STAFF REPORT

SUBJECT: H-2021-0001
Lost Rapids Drive-Through – CUP

LOCATION: W. side of N. Ten Mile Rd., north of W. Lost Rapids Dr. (Lot 13, Block 1, Lost Rapids Subdivision – Parcel #R5330761300), in the NE ¼ of Section 27, Township 4N., Range 1W.

Conditional use permit for a drive-through establishment within 300-feet of a residential zoning district on 1.61-acres of land in the C-G zoning district.

A. Proposed Site Plan (dated: 2/25/2021)

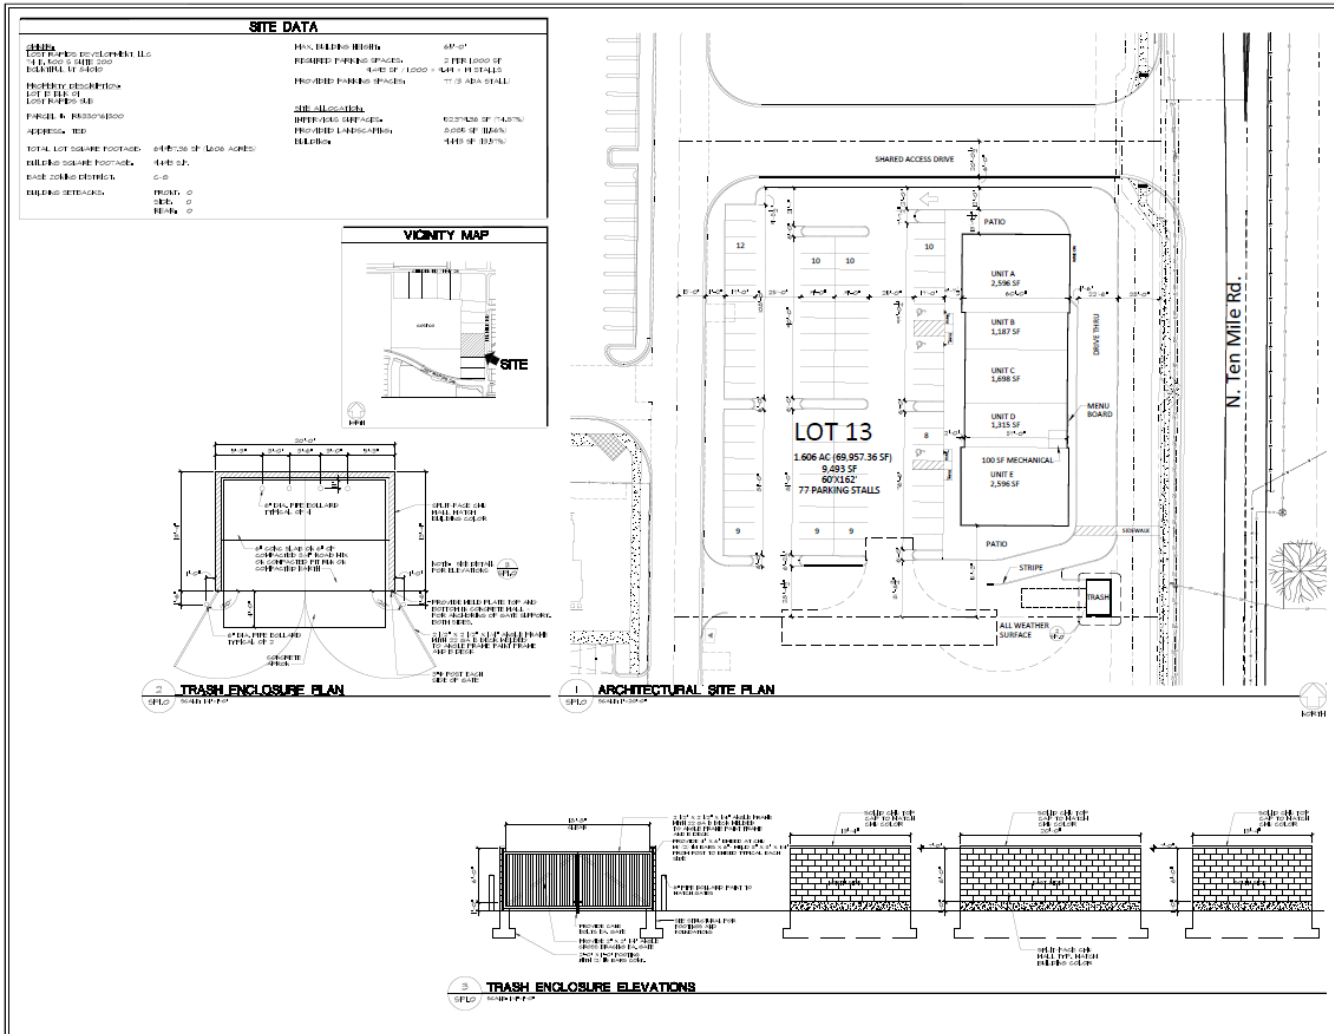
At 259' +/- from the drive-through window to the nearest drive-aisle that serves the row of parking in front of the building, Staff believes the stacking lane has sufficient capacity to serve the use without obstructing driveways and drive aisles by patrons.

Although the stacking lane isn't a separate lane from the driveway that provides access to the site and access to parking, more than 13 vehicles would have to be waiting in the stacking lane before it would block access to the parking area (based on 259'/20'), which the Applicant doesn't believe will be an issue due to the types of restaurants being considered for this tenant space.

The stacking lane exceeds 100' in length and an escape lane is proposed.

The drive-through is visible from N. Ten Mile Rd., a public street along the east boundary of the site, for surveillance purposes.

A minimum one (1) bicycle parking space is required to be provided for every 25 vehicle spaces or portion thereof per UDC [11-3C-6G](#); bicycle parking facilities are required to comply with the location and design standards listed in UDC [11-3C-5C](#). **Bicycle parking shall be depicted on the site plan submitted with the Certificate of Zoning Compliance application in accord with the aforementioned standards.**

Pedestrian Walkways: A pedestrian walkway is depicted on the site plan from the perimeter sidewalk along N. Ten Mile Rd. to the main building entrance as required by UDC 11-3A-19B.4a. **Where pedestrian walkways cross vehicular driving surfaces, the walkways are required to be distinguished from the vehicular driving surfaces through the use of pavers, colored or scored concrete, or bricks as set forth in UDC 11-3A-19B.4. The site plan submitted with the Certificate of Zoning Compliance application should reflect compliance with this standard.**

Staff recommends a pedestrian walkway, minimum 5-feet in width, is provided to the sidewalk in front of the building from the sidewalk along the west boundary of the site; and along the north boundary of the site between the sidewalk along Ten Mile Rd. and the sidewalk along the west boundary of the site for safe pedestrian access. The walkways should be distinguished from the vehicular driving surface as noted above.

Street buffer landscaping, including a sidewalk, along N. Ten Mile Rd. was installed with development of the subdivision. **Because the drive-through lane and back of the building (with mechanical equipment) will be highly visible from N. Ten Mile Rd., Staff recommends additional landscaping (i.e. coniferous trees/bushes) is provided within the street buffer along to screen this area and these functions while preserving a clear view of the drive-thru window for surveillance purposes.**

2. The site plan and landscape plan submitted with the Certificate of Zoning Compliance application shall be revised as follows:
 - a. The stacking lane, menu and speaker location(s), and window location shall be depicted in accord with UDC [11-4-3-11B](#).

- b. Depict bicycle parking as set forth in UDC [11-3C-6G](#) in accord with the location and design standards listed in UDC [11-3C-5C](#).
 - c. Where pedestrian walkways cross vehicular driving surfaces, the walkways shall be distinguished from the vehicular driving surfaces through the use of pavers, colored or scored concrete, or bricks as set forth in UDC [11-3A-19B.4](#).

- e. Include additional landscaping (i.e. coniferous trees/bushes) within the street buffer along N. Ten Mile Rd. to screen the back side of the building and mechanical equipment while preserving a clear view of the drive-thru window for surveillance purposes.

- f. Depict a minimum 5-foot wide walkway from the sidewalk along the west boundary of the site to the sidewalk in front of the building; ~~and along the north boundary of the site between the sidewalk along Ten Mile Rd. and the sidewalk along the west boundary of the site.~~ The walkway shall be distinguished from the vehicular driving surfaces through the use of pavers, colored or scored concrete, or bricks as set forth in UDC [11-3A-19B.4](#).
